APPLICATION NO.	FILING DATE	FIRST NAMED INVENTOR	ATTORNEY DOCKET NO.	CONFIRMATION NO.
10/564,761	01/17/2006	Tatsushi Ogawa	040894-7374	1486
	7590 06/11/200 VIS & BOCKIUS LLP		EXAMINER	
1111 PENNSY	LVANIA AVENUE N		LOW, LINDSAY M	
WASHINGTON, DC 20004			ART UNIT	PAPER NUMBER
			3721	
			MAIL DATE	DELIVERY MODE
			06/11/2008	PAPER

Application No.	Applicant(s)					
	10/564,761	OGAWA ET AL.					
Office Action Summary	Examiner	Art Unit					
	LINDSAY M. LOW	3721					
The MAILING DATE of this communication app Period for Reply	ears on the cover sheet with the c	orrespondence address					
A SHORTENED STATUTORY PERIOD FOR REPLY IS SET TO EXPIRE 3 MONTH(S) OR THIRTY (30) DAYS, WHICHEVER IS LONGER, FROM THE MAILING DATE OF THIS COMMUNICATION.  - Extensions of time may be available under the provisions of 37 CFR 1.136(a). In no event, however, may a reply be timely filed after SIX (6) MONTHS from the mailing date of this communication.  - If NO period for reply is specified above, the maximum statutory period will apply and will expire SIX (6) MONTHS from the mailing date of this communication.  - Failure to reply within the set or extended period for reply will, by statute, cause the applica

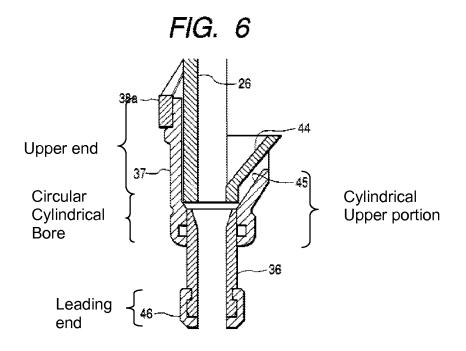
Regarding new claims 17-20, refer to the figure below for the designations of the hollow member with its proximal and distal ends, the first circular cylindrical bore, and the second circular cylindrical bore.

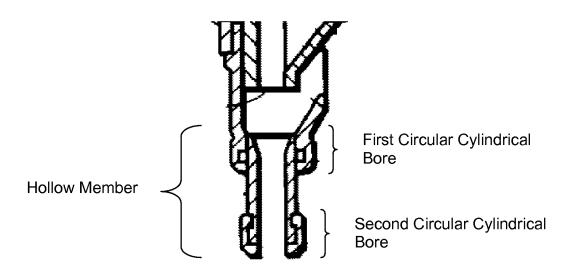
Regarding the amendments to claim 1, refer to the figure below for the designations of the upper end, leading end, cylindrical portion, and the circular cylindrical bore.
